**Application for Revision to Approved Plans**

Project Address: 10 Hobby Lane, Bedford, NY

Revised Rear Deck and outside kitchen & Roof Added over outside kitchen.

Revised Deck and outside Kitchen with New Roof  
Added. No Footprint Change.

REAR ELEVATION

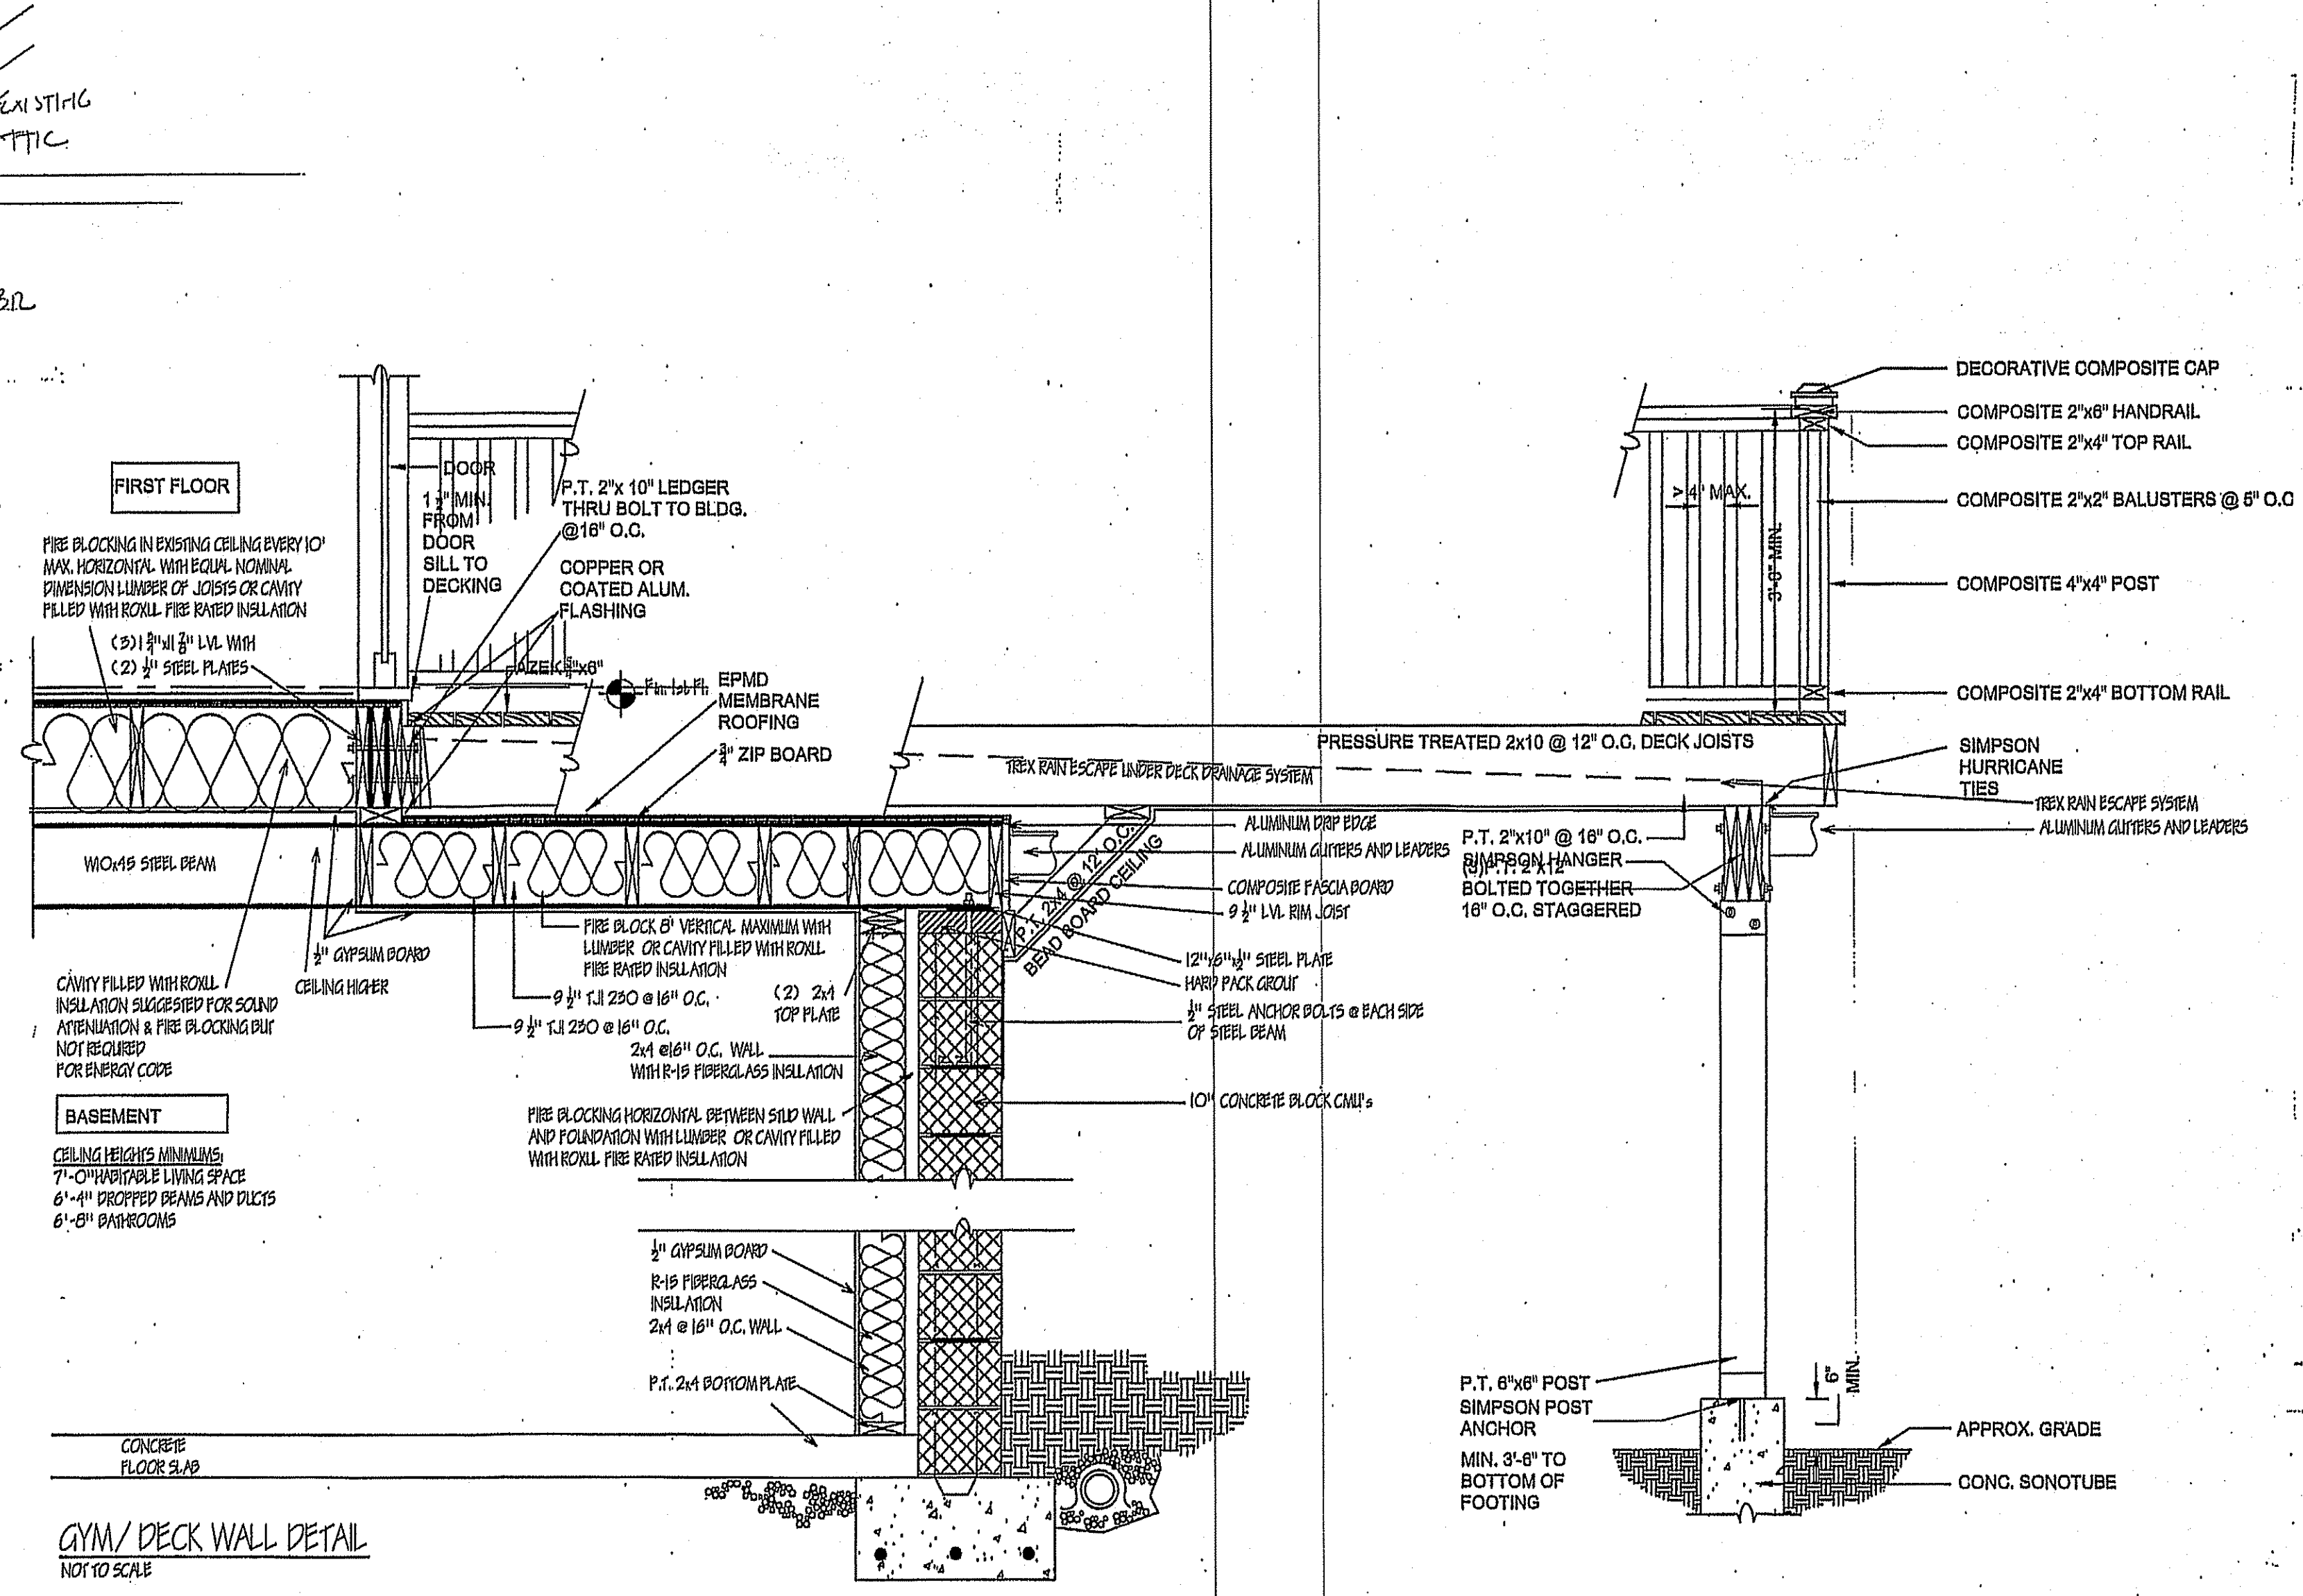
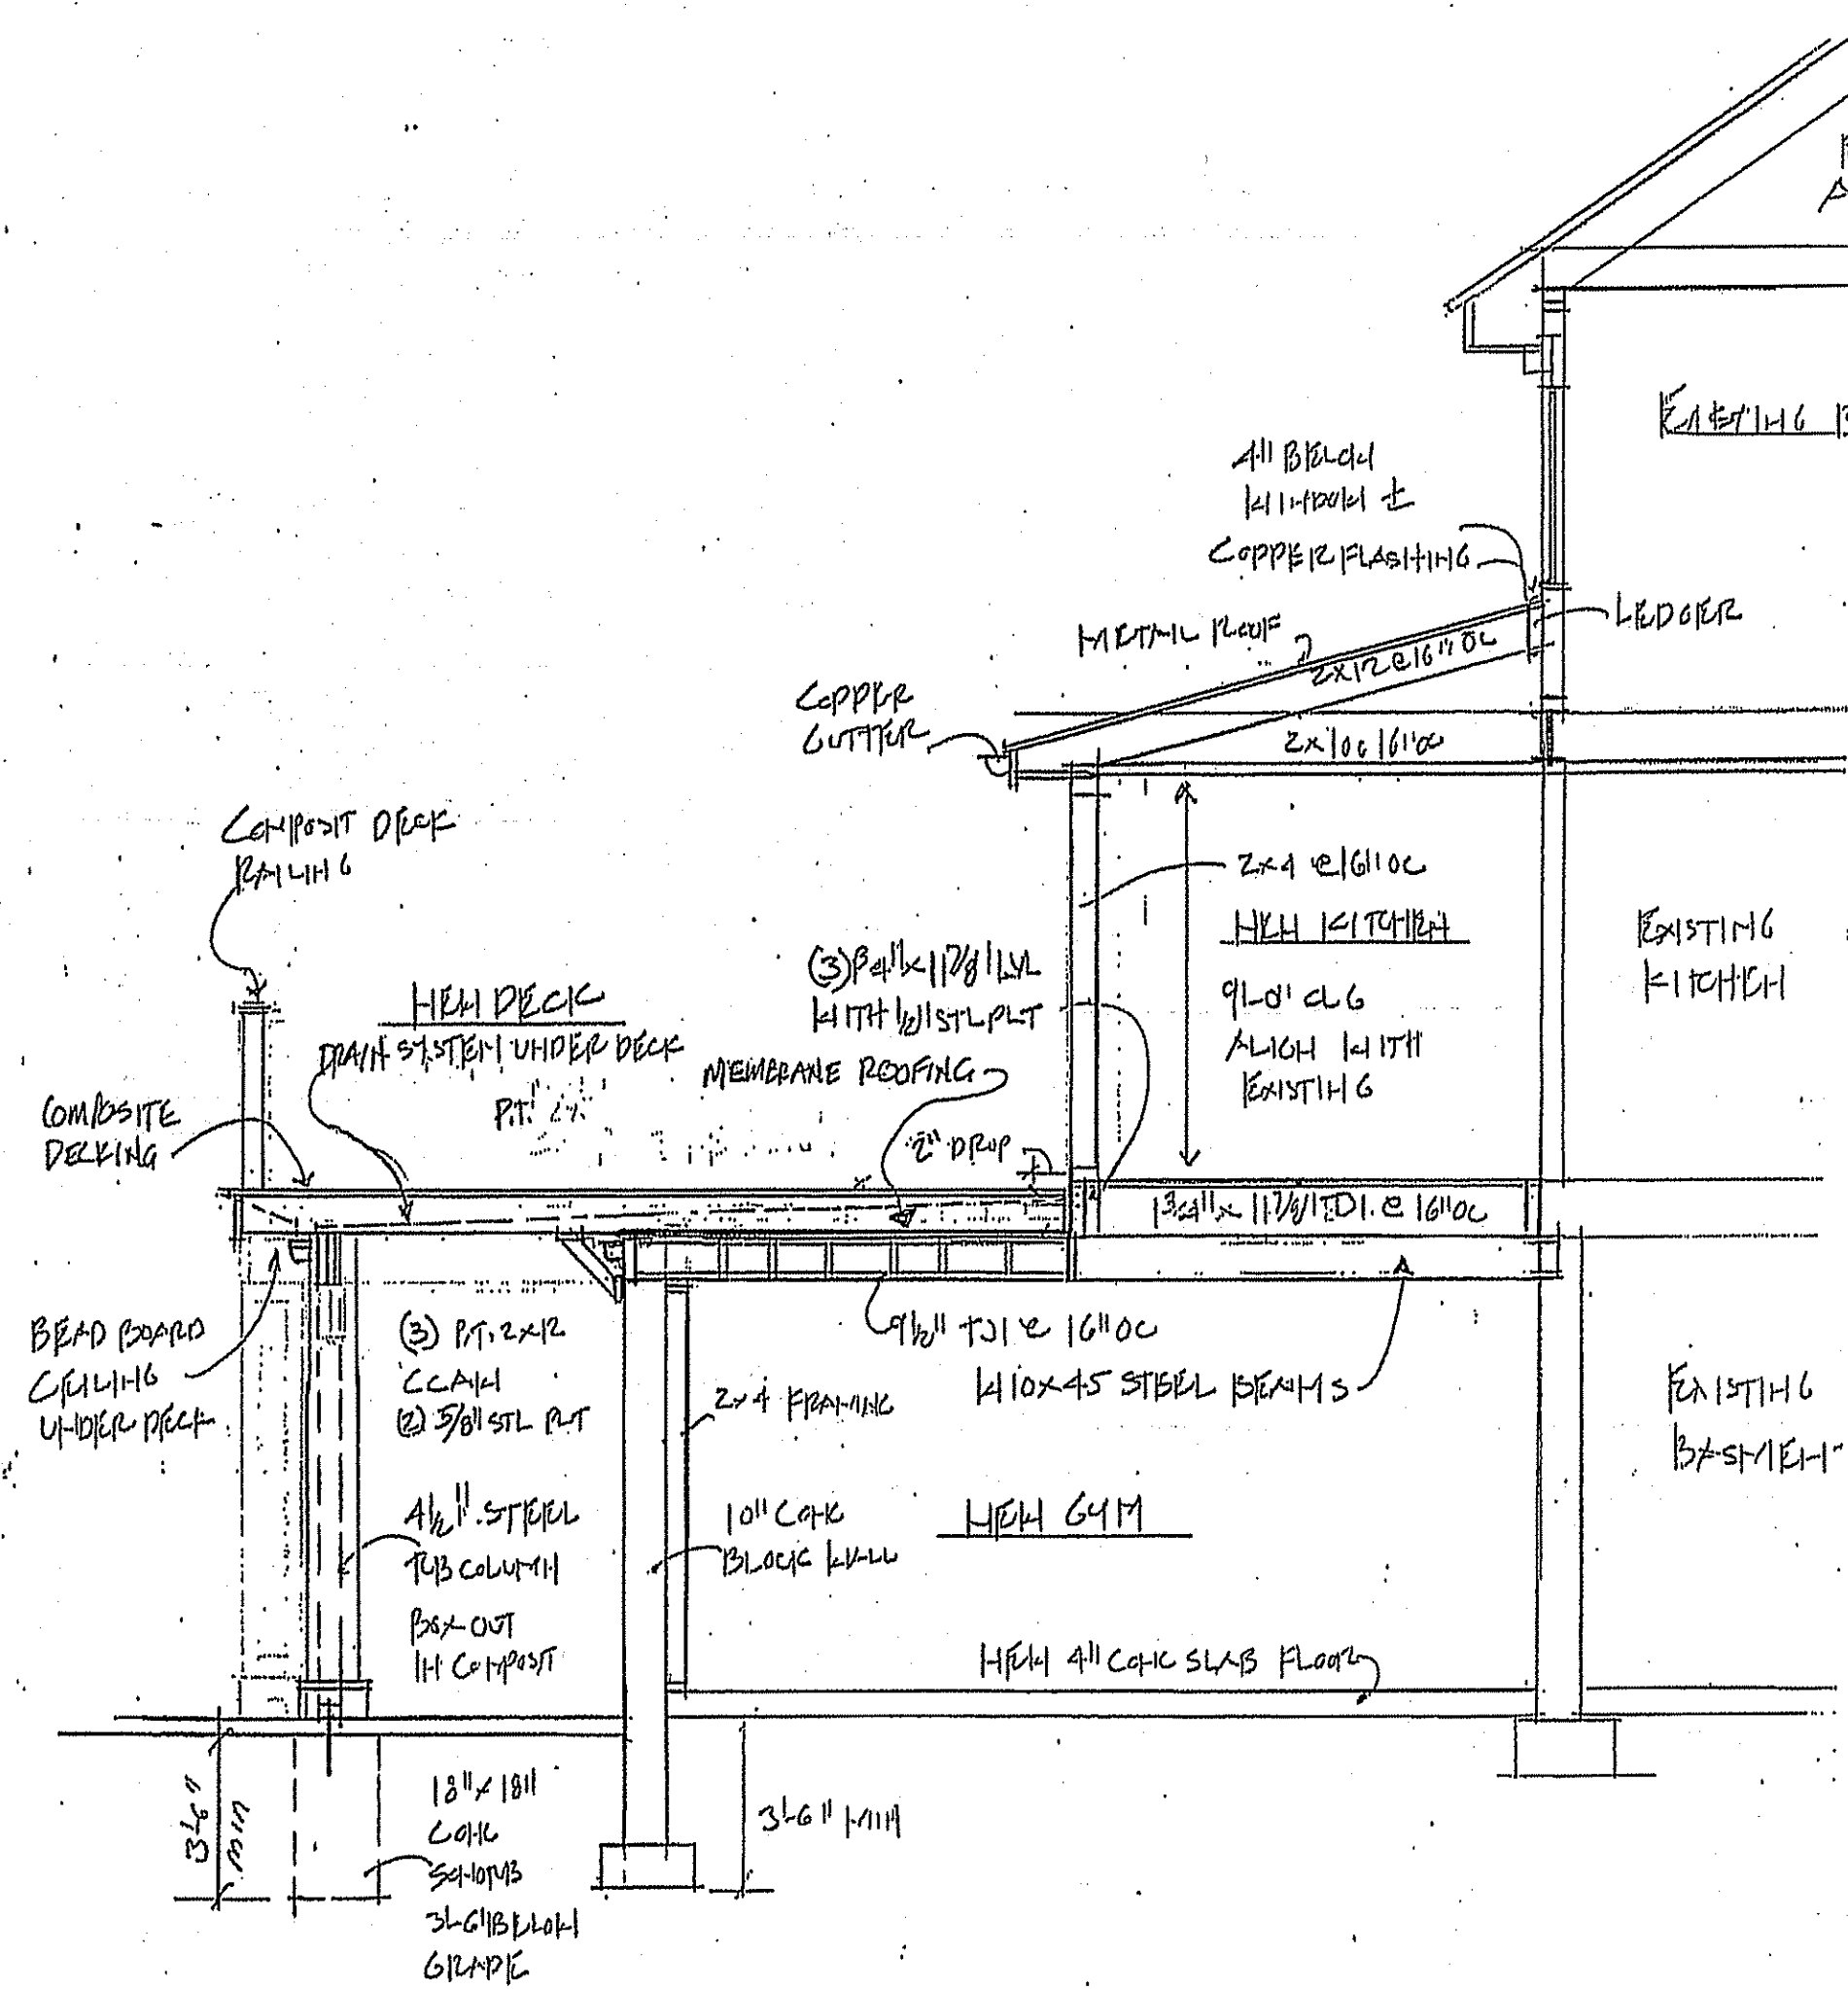
REVISOR REAR DECK & ROOF ADDED OVER KITCHEN AREA 8/15/20  
 BLUE SLATE STEP TREADS REVISOR PER BRAM REVIEW 4/25/19  
 ISSUED 7/30/18
